**APPLICATION FOR PERMISSION
UNDER SECTION 16 OF
THE TOWN PLANNING ORDINANCE
(CAP.131)**

For Official Use Only 請勿填寫此欄	Application No. 申請編號	A/YL-TYST/1181
	Date Received 收到日期	24 AUG 2022

Section 16 Planning Application for Construction and Operation of Proposed Yuen Long South Effluent Polishing Plant (YLSEPP) at Various Lots in D.D. 117 and D.D. 119 and Adjoining Government Land, Kung Um Road, Yuen Long, New Territories

Planning Application No. A/YL-TYST/1181

SHEET NUMBER
60631936/EIA/YLSEPP/FIGURE 9.7

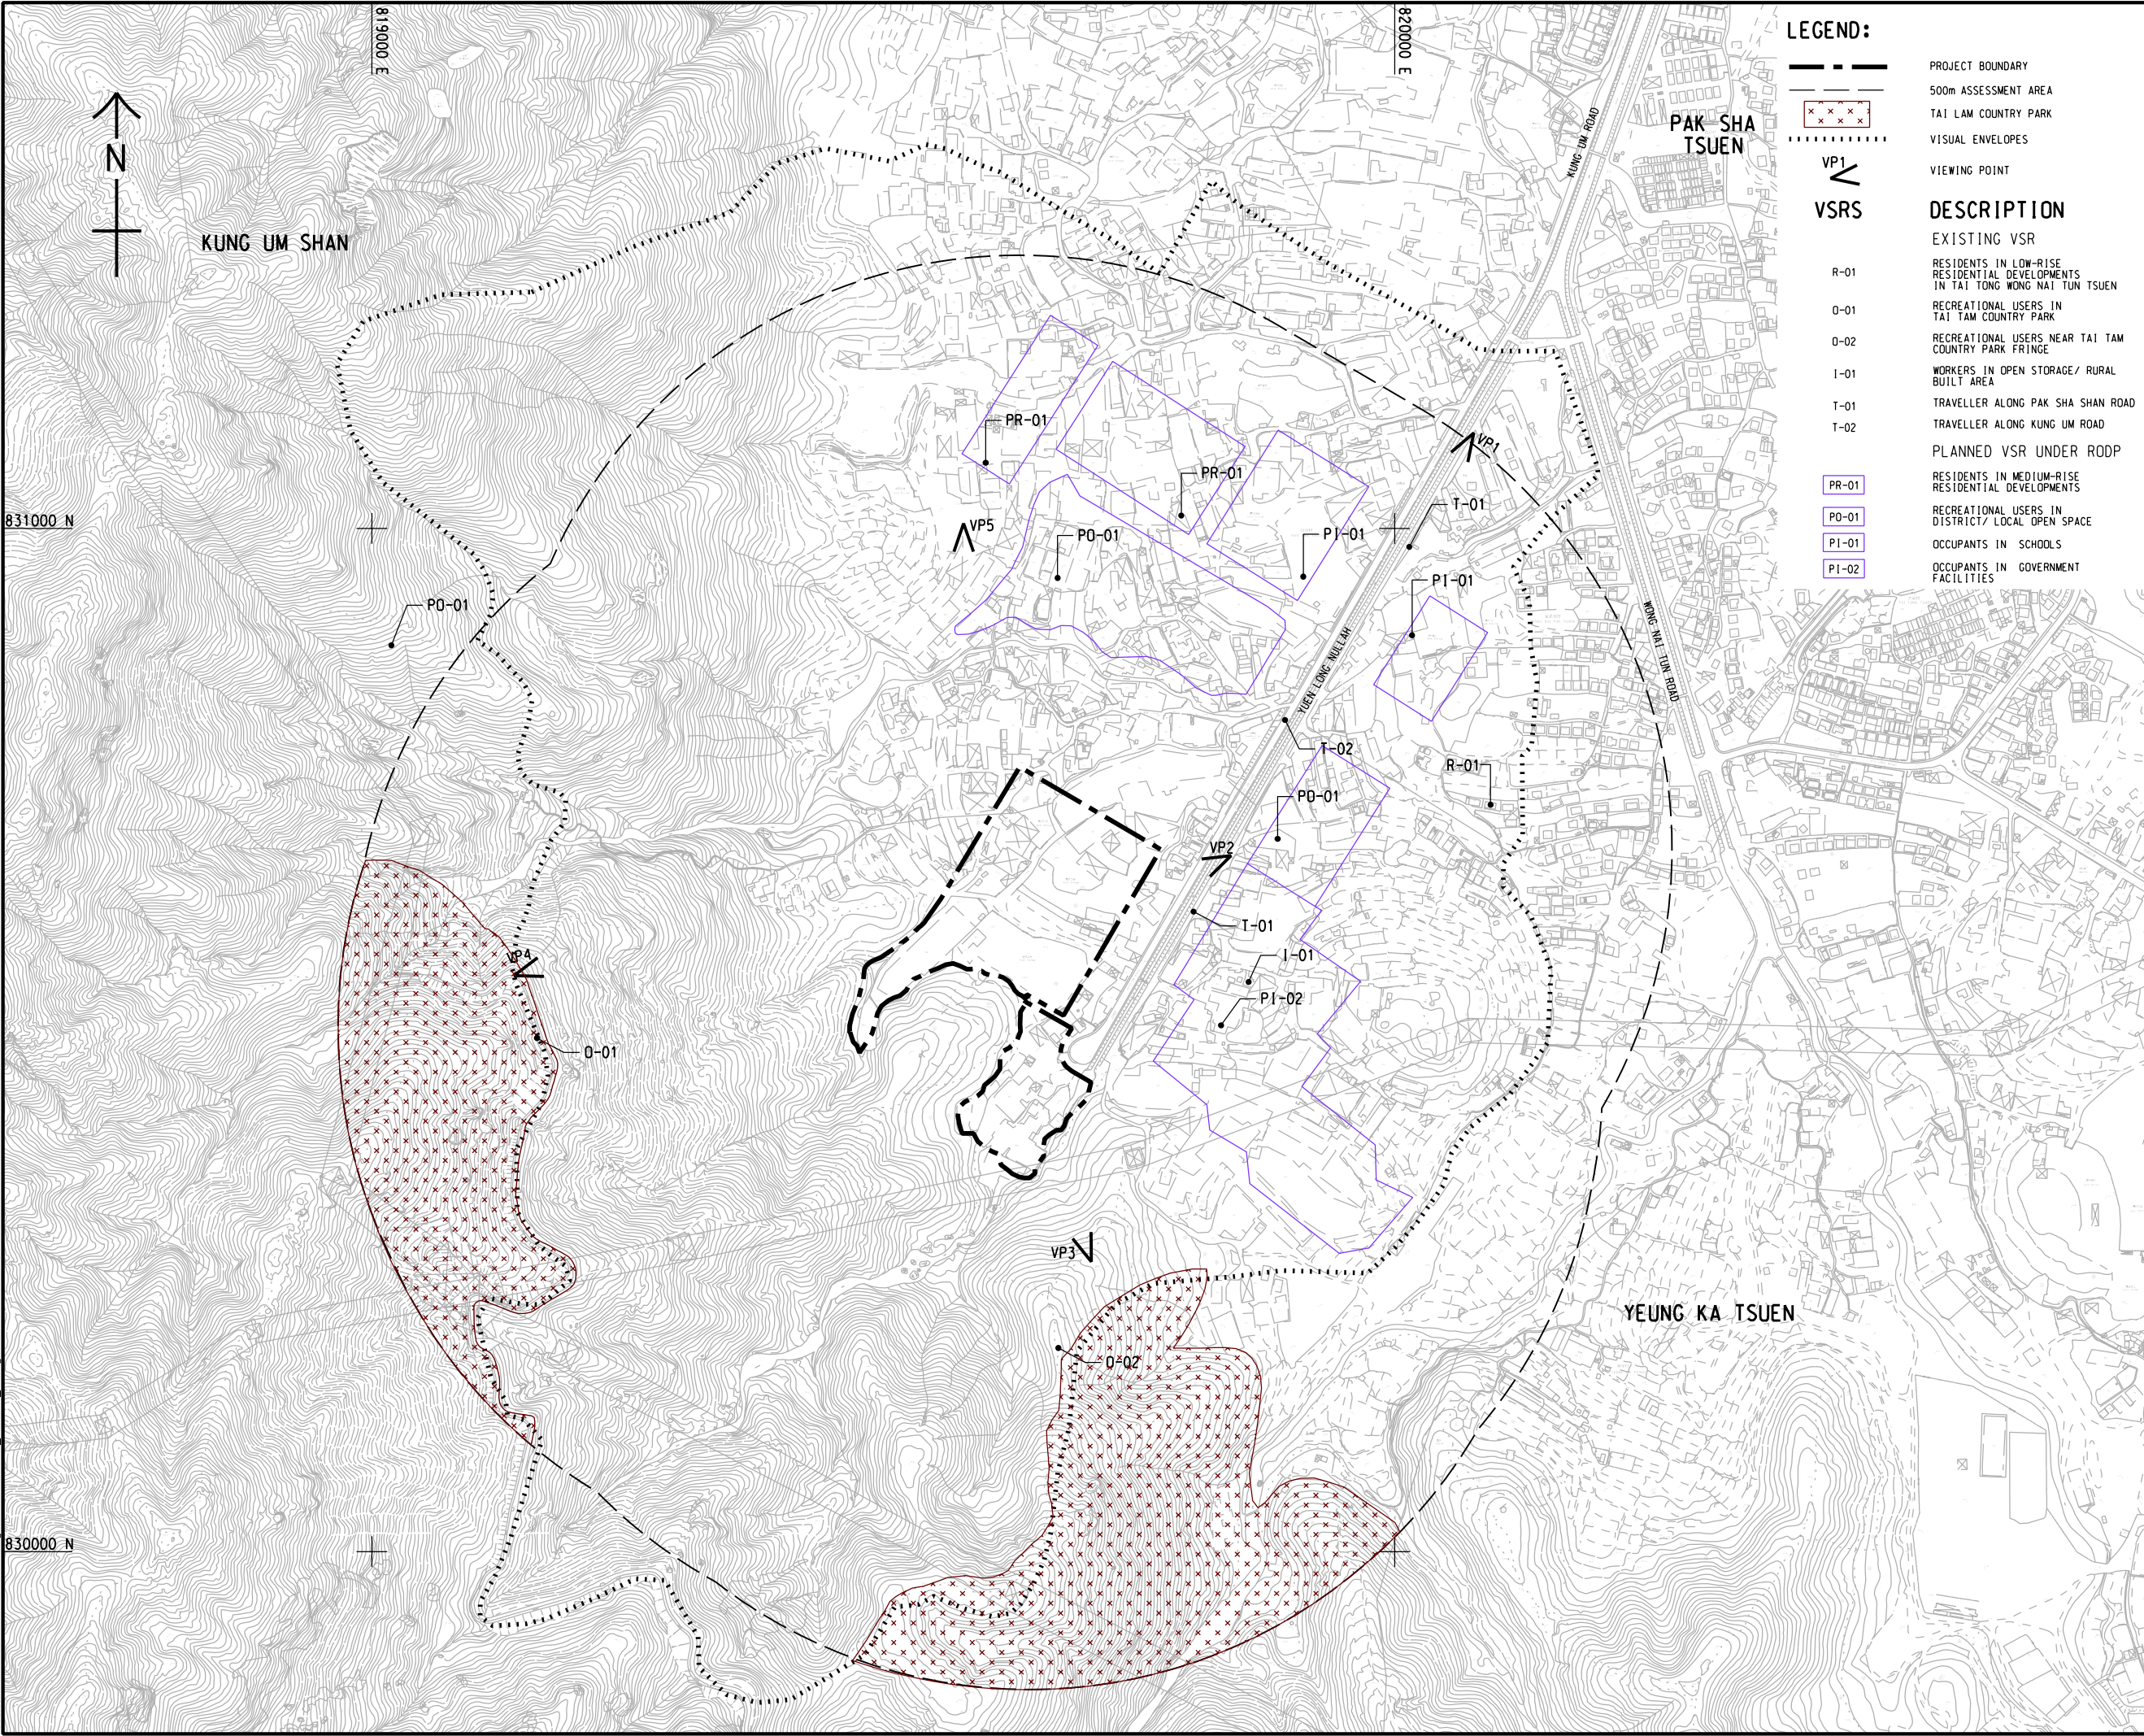
4.1	Comment on Appendix H – Visual Impact Assessment (VIA) Figure 9.7 – This figure (i.e. Visual Envelope and Key VSRs with Development Proposal Overlaid) is missing in this VIA. Please supplement.	Noted and revised. Please refer to the supplementary pages.
